Victor T. Massey

STRIMBU, GREGORY J

Office Action Summary	Application No. 10/673,643	Applicant(s) MASSEY ET AL.	
	Examiner Gregory J. Strimbu	Art Unit 3634

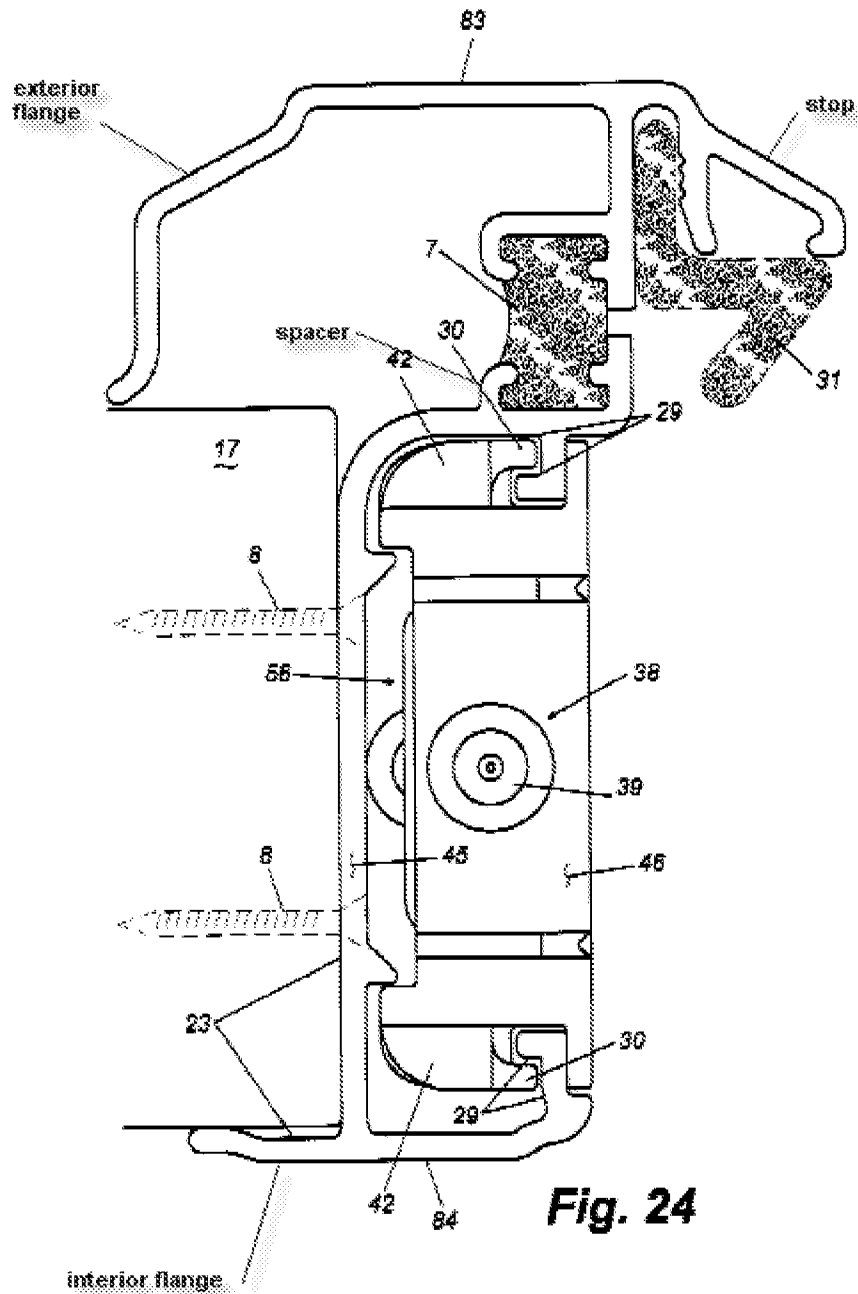
Claims 1-21, 39 and 47 are rejected under 35 U.S.C. 103(a) as being unpatentable over Massey et al. (6491326) in view of Hendrickson et al. (US 6684571) and Davis (US 3364624). Massey et al. discloses an astragal assembly 27 for attachment to a passive door 17 having an interior surface, an exterior surface opposite to the interior surface, and an outer edge extending from the exterior surface to the interior surface, comprising: a frame 28 having an exterior portion 83, an interior portion 84 spaced from and opposed to the exterior portion, and a side portion 45 extending between the exterior portion and the interior portion disposed opposite the outer edge of the passive door when the astragal assembly is affixed thereto, a gasket 7

interconnected between said exterior portion and said side portion, an interior flange (labeled below) extending away from where said interior portion meets said side portion to engage the interior surface of the passive door when the astragal assembly is affixed thereto, and an exterior flange (labeled below) opposite said interior flange and extending away from where said exterior portion is connected to said gasket 7 to engage the exterior surface of the passive door when the astragal assembly is affixed thereto, wherein an elongated open channel is defined in the frame with sides formed by the exterior portion and the interior portion and a base formed by the side portion, the elongated open channel having an opening extending between the exterior portion and the interior portion and opposed to the side portion; and an insert 25, 46 (see figure 2) retained within the elongated open channel in the frame, a stop (labeled below), a second gasket 31, a thermal break 7, hooks 29, a strike plate 21. Massey et al. is silent concerning a spacer and a wooden insert.

However, Davis, in figure 4, discloses an astragal 15" comprising a spacer 28" having a distal end 60" protruding outwardly from a major surface (not numbered, but shown in figure 4) of a side portion in a direction that is substantially parallel to an interior flange 20" and substantially perpendicular to said major surface.

It would have been obvious to one of ordinary skill in the art to provide Massey et al. with a spacer, as taught by Davis, so as to be able to adjust the position of the astragal to accommodate different door dimensions.

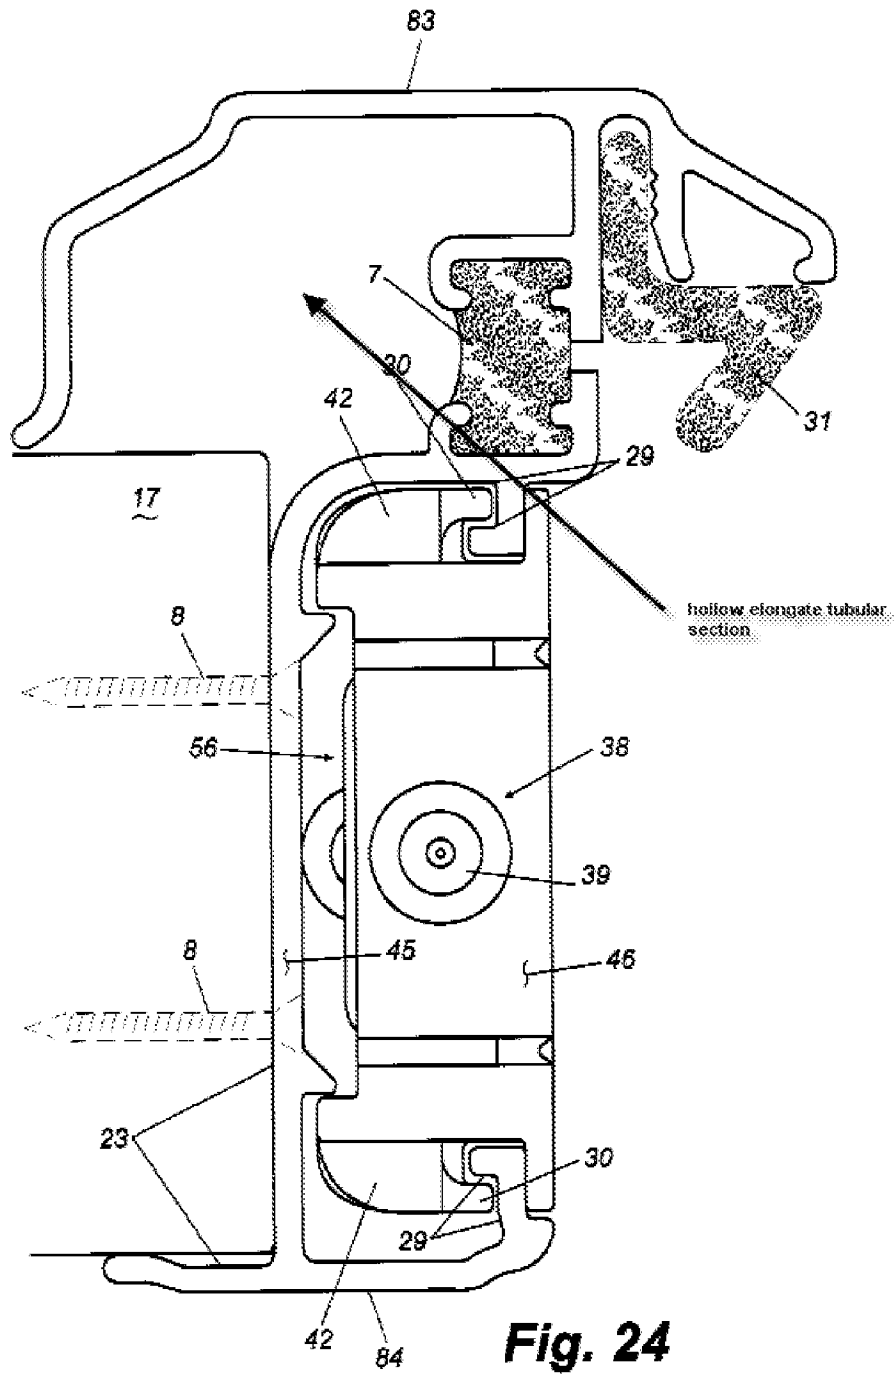
Regarding the applicant's comments concerning Davis, the examiner respectfully disagrees. It should first be noted that claim 1 is only reciting the subcombination of an astragal assembly. Thus, the combination of references only need be capable of attaching to a passive door and only need be capable of performing as the applicant has recited. Davis, in figure 4, discloses a spacer 28" since it spaces the plate 18" away from the door jamb J. The spacer 28" prevents an outer edge of the door jamb J from contacting a major surface of the plate 18" and allows air to flow between the outer edge of the door jamb J and the plate 18" since it creates a space between the door jamb J and the plate 18". Clearly, the spacer 28" is capable of performing the functions recited by the applicant. The fact that the spacer 28" does not come into contact with a door is not persuasive because the applicant is only claiming the subcombination of an astragal. The applicant's comments concerning an astral frame assembly being secured to the top and bottom frames of a door is inaccurate. An astral is defined as a narrow, convex molding, often having the form of beading, The American Heritage Dictionary of the English Language, 1973. Thus, an astragal is not limited to being related to a door and definitely is not, by definition, required to be attached to a door. Moreover, an astragal can be attached to a door frame or any other structure since what an astragal is attached to does not determine if it is or is not an astragal.

With respect to claim 16, Massey et al. discloses a hollow elongate tubular section identified below. The section is elongate and tubular since it extends the length of the door and is generally in the shape of a tube. Additionally, the section is hollow since it comprises an unfilled space.
